# INSTRUCTION TO SERVICE

ITS: 59239		May 6, 2021
<b>SECTION:</b>	460-Windows	
<b>WRITTEN BY:</b>	Troy Stutsky	
<b>SUBJECT:</b>	Inspect SDS Window Parts & Function and Rework if Required	
<b>ISSUE:</b>	Some SDS windows with T-Handle release and gas struts were not built to print which can cause the windows not to fully latch in the closed position. Part affected is NF PN 678774.	
<b>SUMMARY:</b>	Inspect the windows for any of the conditions outlined in this document and rework the windows as required.

# ITS59239

**Figure 1: T-Handle Cable Inspection and Repair**

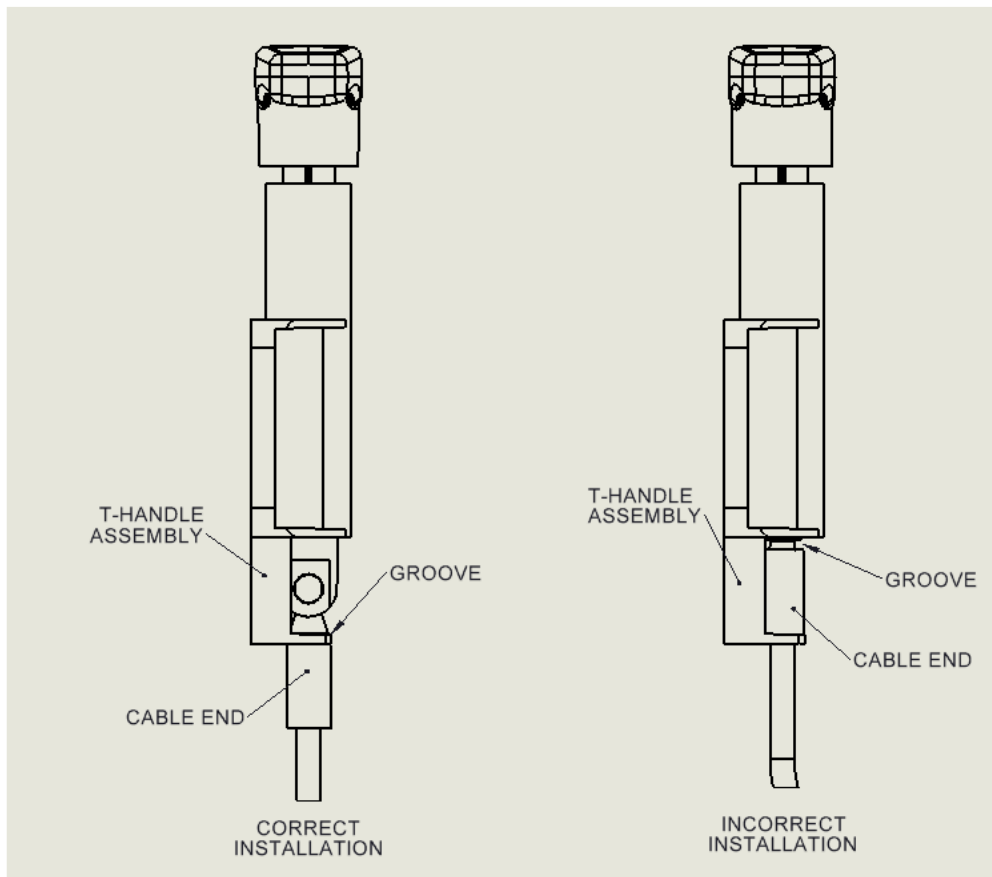
1. Set park brake and chock wheels.
2. Turn the main battery disconnect switch to the “OFF” position.
3. From the inside of the bus, open the window located behind the SDS box by lifting the T-Handle to release the latches and lifting the window up from the outside of the bus.
4. From the outside of the bus, inspect the T-Handle assembly to make sure the T-Handle cable is installed in the correct location. The cable must be captured via the groove in the cable end. The cable cannot be fully captured within the T-Handle assembly. If the cable is captured fully in the T-Handle assembly this can be corrected by removing the cable from the T-Handle assembly and reassembling via the groove in the cable end. See Figure 1.

**Figure 2: Removal of Outer D-seal if Required**

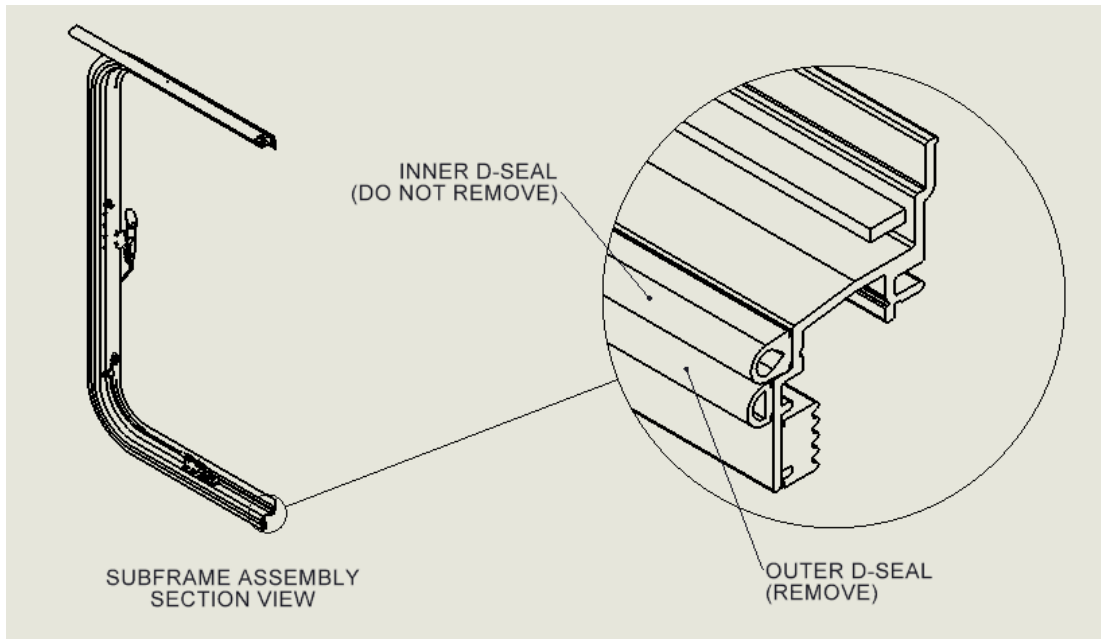
5. Inspect the rubber seals on the subframe of the SDS window. If the window has two side-by-side D-seals on the subframe of the window, the outer D-seal must be removed. This D-seal has been found to restrict the window from being able to fully latch in the locked position. There is a detailed instruction on how to remove this D-seal in active ITS-59216 that can be obtained from your local New Flyer Service Representative. See Figure 2 for outer D-seal location reference.

**Figure 3: Old Latch Striker Pin & New Latch Striker Pin Comparison**

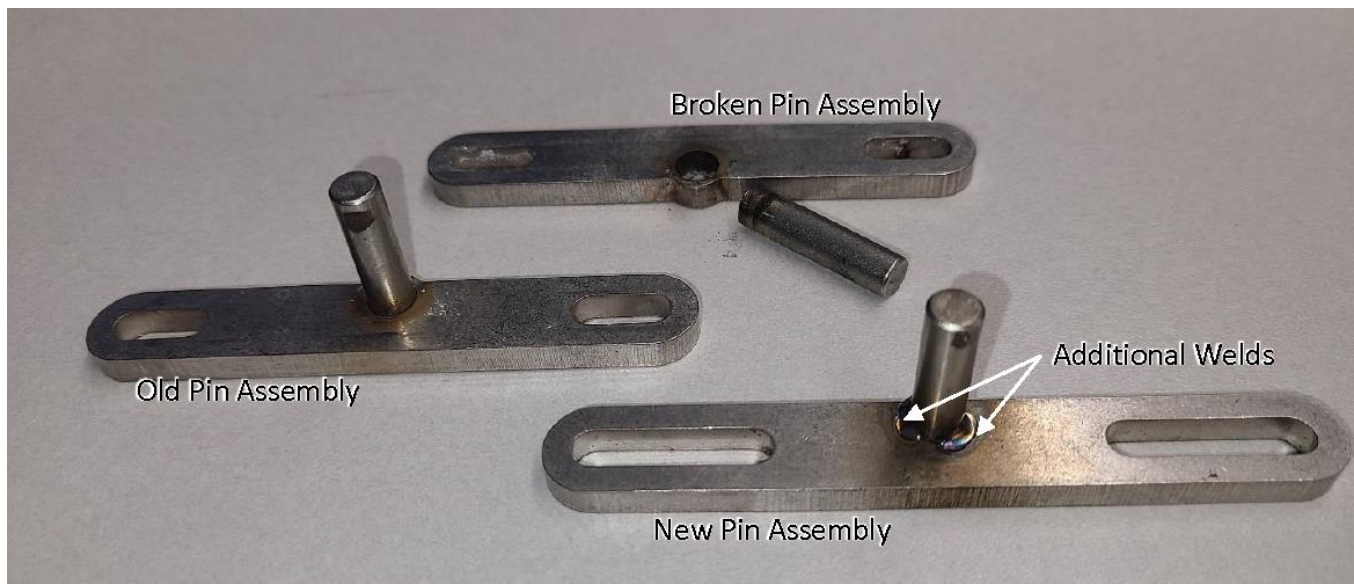
6. Inspect the two latch striker pin assemblies located on the main frame of the window. If the pin assemblies do not have the double welds in the location where the pin joins to the pin bracket, the existing pin assemblies will need to be replaced with new pin assemblies (NF PN 6477370) and new hardware, screws (NF PN 6474082), nuts (NF PN 6487878). See Figure 3 for old pin assembly vs new pin assembly for inspection reference. There is a detailed instruction on how to remove and replace the latch striker pin assemblies in active ITS-59216 that can be obtained from your local New Flyer Service Representative. The new pin assemblies and hardware to secure them will be provided under ITS-59216.

**Figure 4: Inspect and Shim Latches if Required**

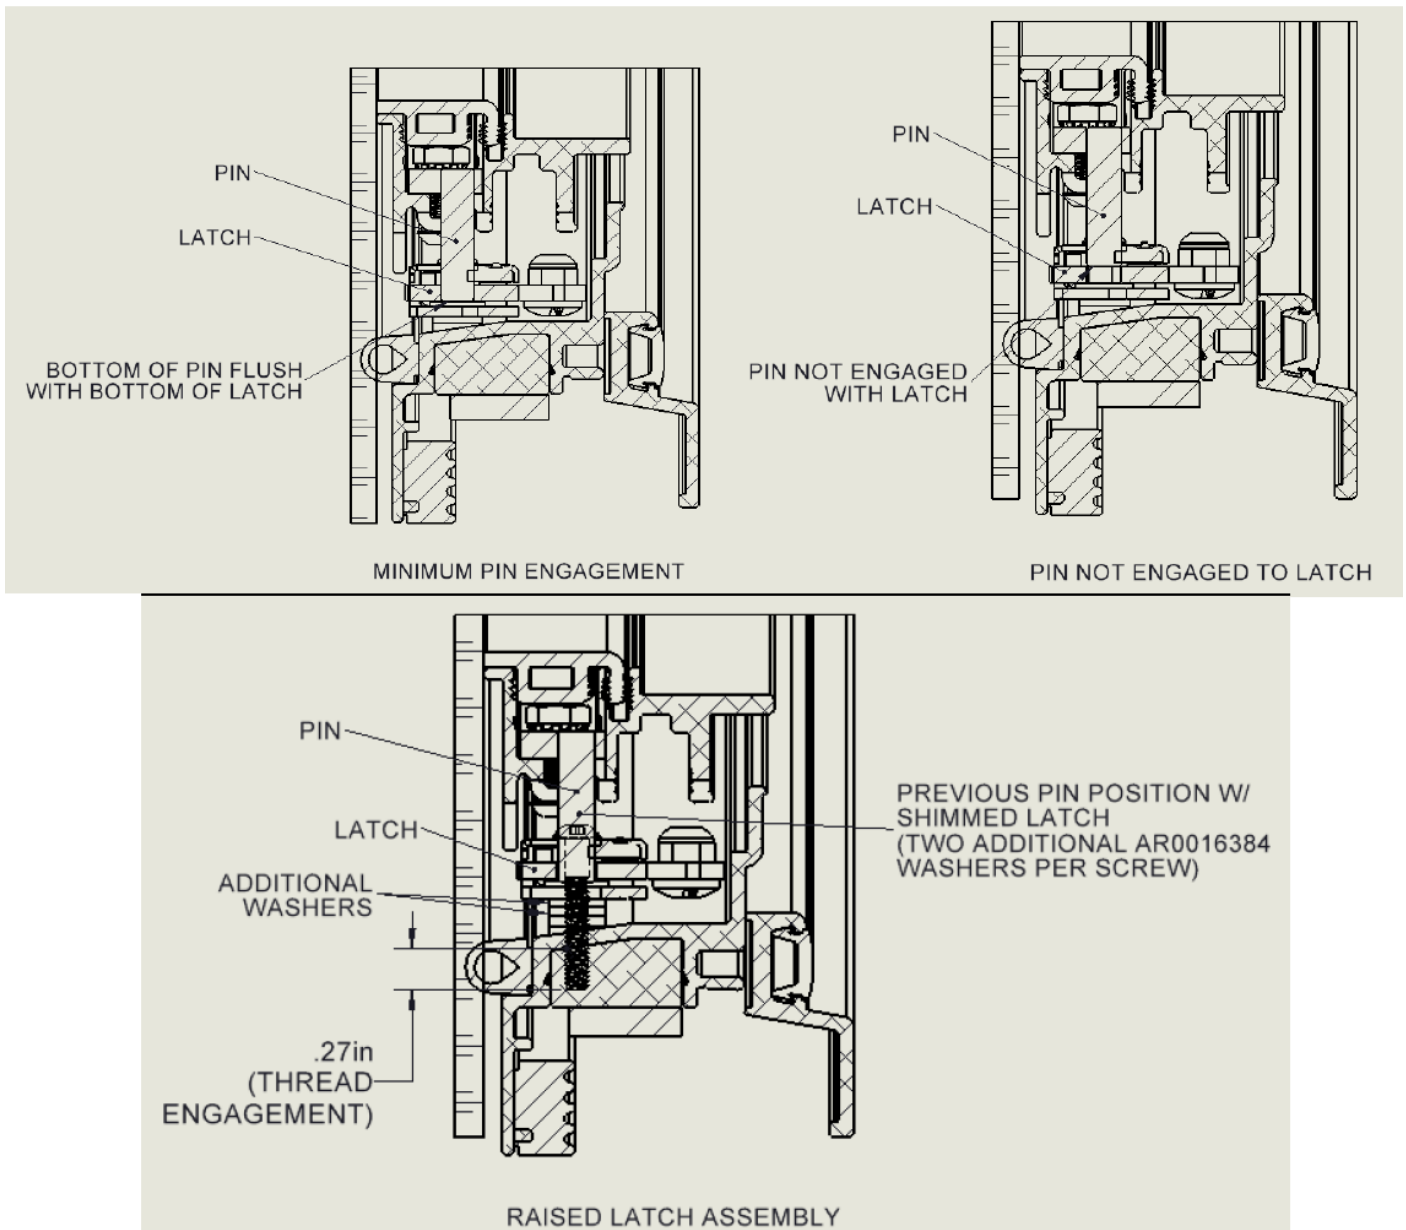
7. Place the SDS window gently in the lowered position with out closing it. Inspect the vertical latch strike pin engagement within the rotary latch on both latches. Ensure that the bottom of the latch pins rest flush or slightly below the bottom of the rotary latch. Windows with inadequate pin engagement must have the rotary latch assembly shimmed with additional washers (NF PN 6488222) to achieve proper engagement. To maintain proper latch mounting screw engagement, no more than two additional washers (0.125" height) are to be added to the two that are existing per screw. It is acceptable to have a maximum total of four washers stacked on top of each other per latch screw to maintain proper screw engagement with the subframe. See Figure 4.

8. If the latch striker pins engage the latches at the proper depth as outlined in step 7, no additional washers are required however, the latch mounting hardware should be removed, 1-2 drops of Loctite 243 (NF PN 081034) added to the threads of the hardware and the hardware should be retightened, hand-tight, using a hand tool only.
